SN: 09/115,764 Group: 3682

Teichert (U.S. Patent No. 5,339,783)

Modified Exhibit

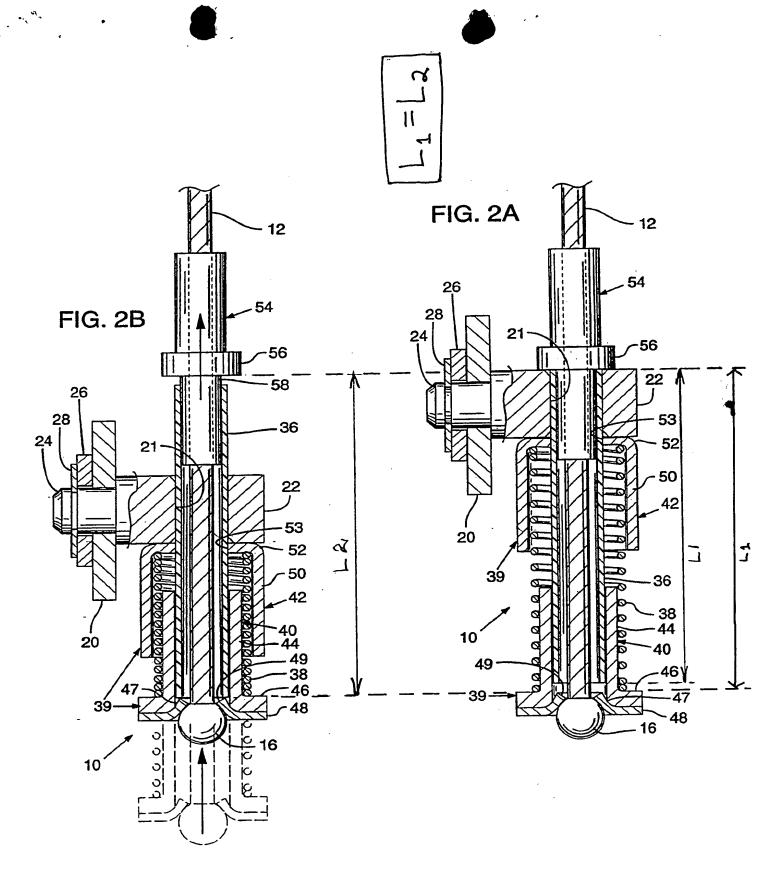
has referenced Figure 2a and 2b of Teichert. Although the drawings are not

necessarily drawn to scale, the Examiner has made a mistake in measuring the

drawings. Referring to the Examiner's Exhibit, the Examiner has drawn distance L1

too short--the Examiner did not draw L1 to extend all the way to the same point on the

guide 40 as he did in Figure 2b. Rather, as shown on the attached modification of the

Examiner's Exhibit, the Examiner mistakenly shortened the distance L1 to exclude the

last coil in this spring of Teichert in Figure 2a. This apparently resulted in the

Examiner measurement that the distance L1 was shorter that the distance L2, when in

fact the distance between the guide 40 and fitting 54 does not and cannot change

between Figure 2A and 2B.

Applicant's modification of the Examiner's exhibit is attached. The elements

40 and 54 from Fig. 2A have been cut out and placed adjacent the same elements in

Fig. 2B. As is clear from this exhibit, the distance between the components does not

change.
